HEWLETT-PACKARD

FROM: Greg Shue
TO: NCITS T10
DATE: March 30, 1998
RE: Reconnect time-out

The text of these proposals follows; it references SBP-2 Revision 3d.

Figure 16 – Login ORB

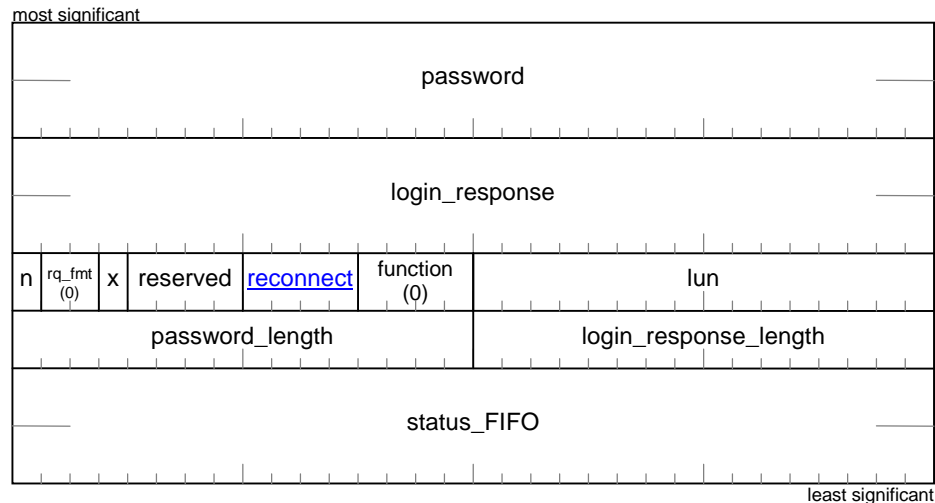
[The *reconnect* field shall specify the desired reconnect time-out as \$2^{\text{reconnect}}\$ seconds. The default reconnect time-out, when *reconnect* is zero, is one second. The target may not be able to support the requested value; see *reconnect_hold* in the login response data below.](#)

Figure 17 – Login response

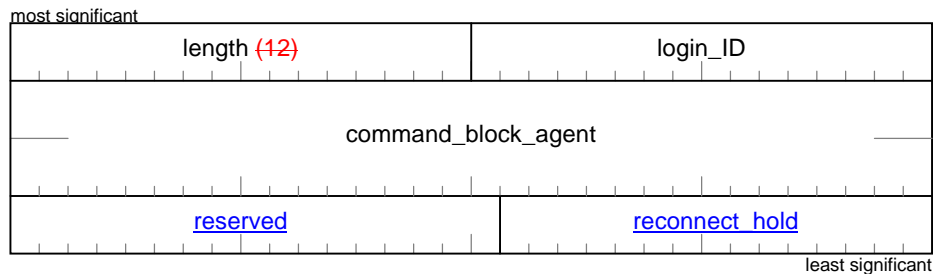
If the login fails the contents of the response buffer are unspecified. Otherwise, upon successful completion of a login, the ~~response is returned in the format illustrated below~~ target shall store a minimum of 12 bytes of login response data and may store up to the entire 16 bytes illustrated below so long as the amount of data stored is an integral number of quadlets. Truncated login response data shall be interpreted as if the omitted fields had been stored as zeros.

The *length* field shall contain the length, in bytes, of the login response data ~~and shall be equal to 12.~~

The *reconnect_hold* field shall specify the time, in seconds less one, that the target will hold resources for a previously logged-in initiator subsequent to a bus reset. The value of *reconnect_hold* shall not be greater than $2^{\text{reconnect}} - 1$, where *reconnect* is obtained from the login request. If an initiator fails to complete a successful reconnect request within *reconnect_hold* seconds after a bus reset, the target will perform a logout and release all resources held by that initiator (see 8.3).
